UNITED STATES PATENT AND TRADEMARK OFFICE

| APPLICATION NO. | FILING DATE | FIRST NAMED INVENTOR | ATTORNEY DOCKET NO. | CONFIRMATION NO. |
|-----------------------|-------------|----------------------|------------------------|------------------|
| 10/717,590 | 11/21/2003 | Robert C. Tonks | 117738 | 9388 |

| Office Action Summary | Application No. | Applicant(s) |

FIG.1

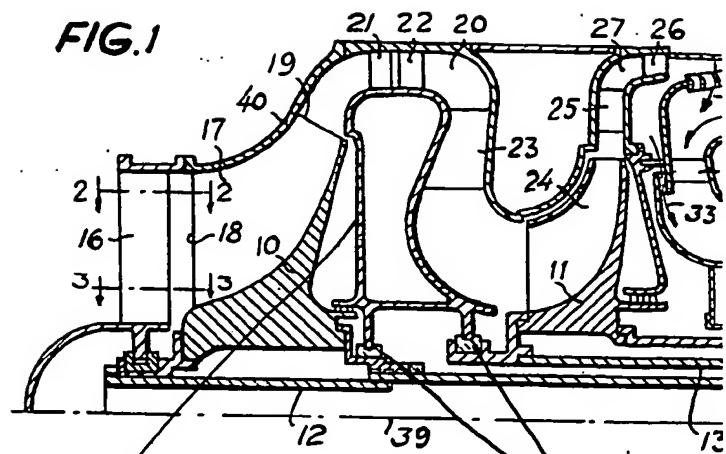
The drawings are objected to as failing to comply with 37 CFR 1.84(p)(4) because reference character "62" has been used to designate both the bypass support vanes and the bearing support radial part. Corrected drawing sheets in compliance with 37 CFR 1.121(d) are required in reply to the Office action to avoid abandonment of the application. Any amended replacement drawing sheet should include all of the figures appearing on the immediate prior version of the sheet, even if only one figure is being amended. Each drawing sheet submitted after the filing date of an application must be labeled in the top margin as either "Replacement Sheet" or "New Sheet" pursuant to 37 CFR 1.121(d). If the changes are not accepted by the examiner, the applicant will be notified and informed of any required corrective action in the next Office action. The objection to the drawings will not be held in abeyance.

The drawings are objected to under 37 CFR 1.84(i), because the drawing figure shows two different views in the same figure; note the sectional portions of vane 54 (adjacent reference numerals 66 and 54) which should not be shown in the view of figure 1. Corrected drawing sheets in compliance with 37 CFR 1.121(d) are required in reply to the Office action to avoid abandonment of the application. Any amended replacement drawing sheet should include all of the figures appearing on the immediate prior version of the sheet, even if only one figure is being amended. The figure or figure number of an amended drawing should not be labeled as "amended." If a drawing figure is to be canceled, the appropriate figure must be removed from the replacement sheet, and where necessary, the remaining figures must be renumbered and appropriate changes made to the brief description of the several views of the drawings for consistency. Additional replacement sheets may be necessary to show the renumbering of the
